SUBJECT: RFI/RI Work Plan for the Early Construction and Operational Disposal Site N-1 (NBN), Central Shops Scrap Lumber Pile (631-2G), and Building 690-N, Process Heat Exchanger Repair Facility (aka Ford Building) Operable Unit (U) (SRNS-RP-2020-00041, Revision 1 Redline, June 2020) (Redline Pages Only) and Savannah River Site's Responses to the Regulatory Comments on the Revision 0 Document, SEMS Number: 93

2. SRS Responses to South Carolina Department of Health and Environmental Control Comments on: RFI/RI Work Plan for the Early Construction and Operational Disposal Site N-1(NBN), Central Shops Scrap Lumber Pile (631-2G), and Building 690-N, Process Heat Exchanger Repair Facility (aka Ford Building) Operable Unit (U), SEMS Number: 93 (SRNS-RP-2020-00041, Revision 0, February 2020)

3. SRS Responses to EPA comments: RFI/RI Work Plan for the Early Construction and Operational Disposal Site N-1 (NBN), Central Shops Scrap Lumber Pile (631-2G), and Building 690-N, Process Heat Exchanger Repair Facility (aka Ford Building) Operable Unit (U), SEMS Number: 93, SRNS-RP-2020-00041, Revision 0, February 2020

Figure 1. Carolina Bays near N-Area

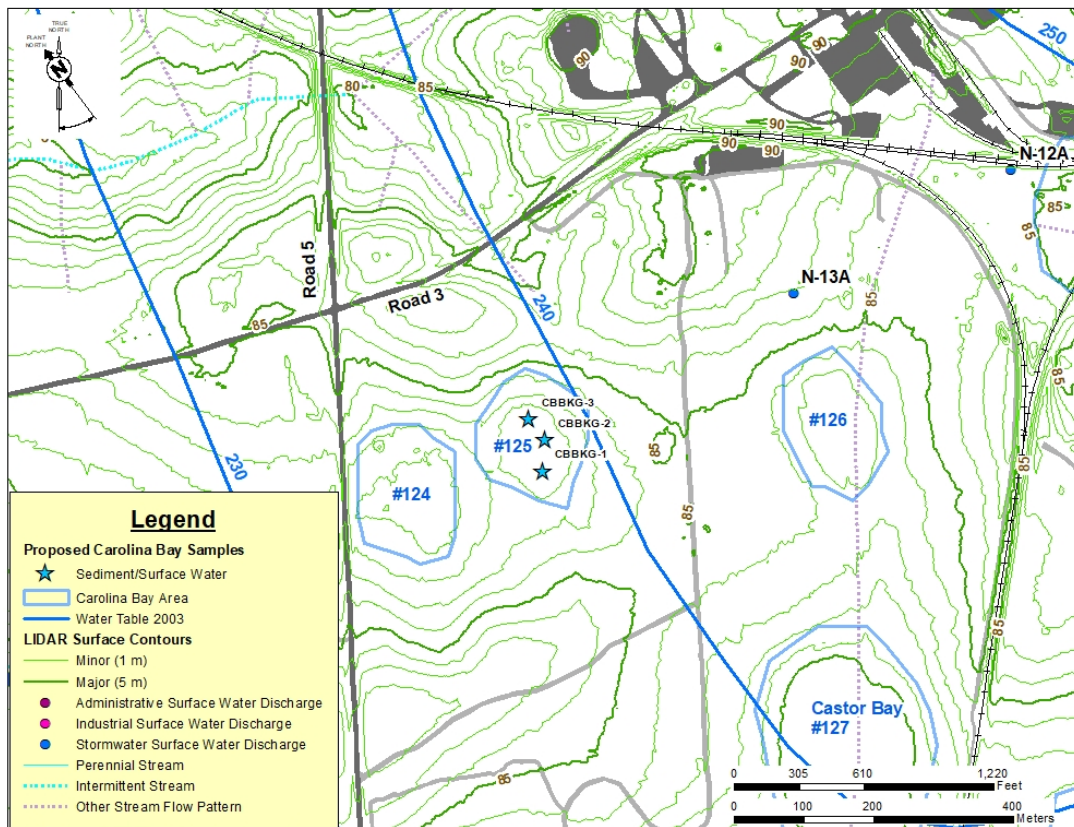
3. Section 3.1.2.2, CSSLP (631-2G), pages 29-30. The last bullet of this section discusses the data gap for background concentrations for sediment and surface water samples and states background samples will be collected at a Carolina Bay that is said to have "little or no impact from SRS operations." After observing the potentiometric map on Figure 2, page 58, it appears that the location of the Unnamed Carolina Bay is down gradient of SRS operations. Please explain how samples can be taken from the Unnamed Carolina Bay in Figure 2 and avoid influence from the subunits included in this work plan and other Central Shops activities.

The Unknown Carolina Bay is down-gradient of N Area with respect to groundwater flow direction. Because the surface elevation of the bay is approximately 269 ft-msl and groundwater is about 240 ft-msl at this location (see attached figure), the bay is not fed by groundwater discharge. Based on the location of surface water discharge point N-13A and area topography, surface water run-off from Central Shops drains into another Carolina Bay #126 to the east of the Unknown Carolina Bay. SRS believes the Unknown Carolina Bay is un-impacted from SRS operations and can be used as the sediment and surface water background location. Please note that the document will be revised to refer to the Unknown Carolina Bay as “Carolina Bay #125” based on a 1989 SREL document, “Carolina Bays of the Savannah River Plant”, which will be added to Section 10. References.

The last sentence of the third paragraph of Section 3.1.2.2 will be revised and the description of Carolina Bay #125 will be added to the end of the third paragraph of Section 3.1.2.2 as follows:

from Carolina Bay #125 will be taken to identify background concentrations for the surface water impoundment area. Because the surface elevation of Carolina Bay #125 is approximately 269 ft-msl and groundwater is about 240 ft-msl at this location, the bay is not fed by groundwater discharge. Surface water run-off from Central Shops drains into another bay identified as Carolina Bay #126 located to the east of Carolina Bay #125. Therefore, Carolina Bay #125 is identified as an unimpacted bay south of N Area (Figure 2).
